Item No. 4 Development Agreement Amendment - 535 Ham Street (Transcona Ward) File DASZ 21/2009

Title: **Request to Amend Council Orders**
File DASZ 21/09 – 535 Ham Street

APPENDIX "A" – DASZ 21/09 Map

Schedule "A" for File No. DASZ 21/09, East Kildonan - Transcona Community Committee, dated September 14, 2009

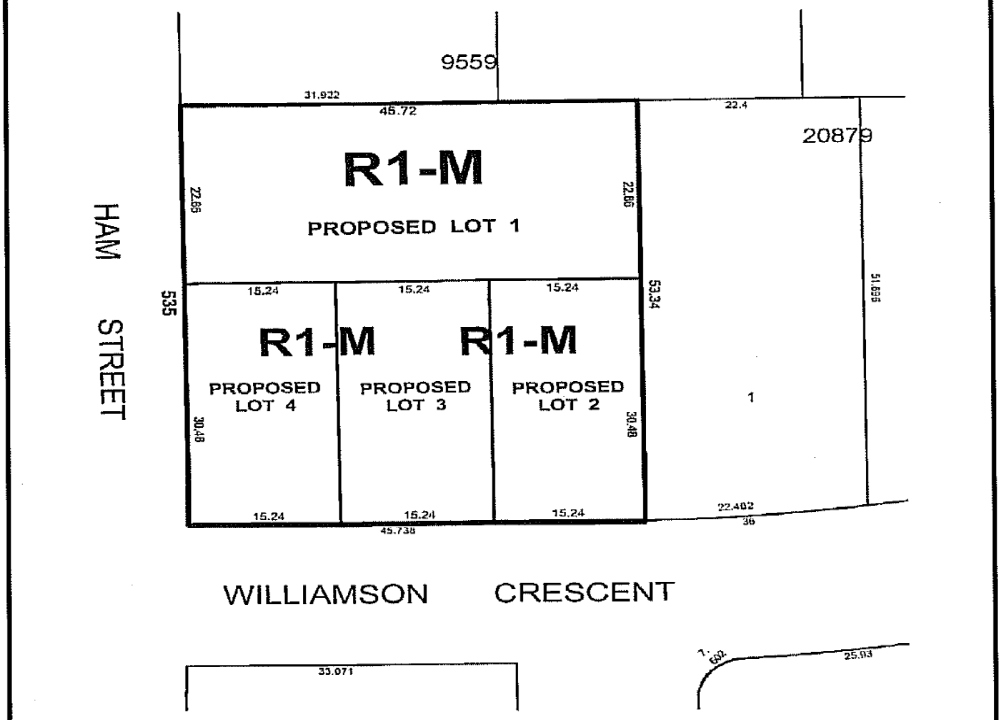
The applicant, Sytko Construction on behalf of the owner Mr. Lloyd Yang has requested that Clause 5 of the August 20, 2009 ACG report contained in Council's instructions be deleted on the basis that this requirement is unfitting to the subdivision, see attached correspondence dated June 15, 2011, Appendix "B".

In section 5 of the servicing agreement it lays out a list of city services that are to be installed on what is known as lot 1 in the subdivision plan. This lot has Ham St. frontage and would maintain that after the subdivision is finalized. The current state of this frontage (and that of the entire portion of Ham St., south of Grassie) is a gravel access road, land drainage into ditches. This lot also makes use of a holding tank and well-drawn water. This is what we would simply like to continue to make use of for lot 1.

Ham St., south of Grassie has seen limited use as a major access route to the abutting development, and the future plans as proposed by the City of Winnipeg include a termination at the intersection of Ham and Grassie in a cul-de-sac adjacent to 316 Grassie blvd. This will now limit the use of Ham as a point of entry altogether. The few homeowners on Ham will now have to travel through the current development to their homes. The far south end of Ham is already terminated in this fashion, with a simple gravel cul-de-sac in place. All previous development done points to Ham St. maintaining its current state, of the graded gravel road and ditch drainage.

If in the future there is intentions to pave all or a large portion of Ham St. my clients would be willing to enter into a servicing agreement at that point, along with all of the other homeowners affected by the City of Winnipeg's future plans. However currently we find developing these services for a stretch of a gravel access road to be an unnecessary cost that may never see any direct benefit to the city or the land owner.

1. That Clause 5 of the August 20, 2009 Administrative Coordinating Group report contained in Item 2 of the Report of the Standing Policy Committee on Property and Development adopted by Council on November 25, 2009, be deleted, namely:

"5. The Developer shall, at no expense to the City, install a full range of services (i.e. Land drainage sewer, concrete pavement, street lighting, and boulevard landscaping) in Ham Street abutting the Planned Area, all as determined by, and to the satisfaction of, the Director of Public Works."
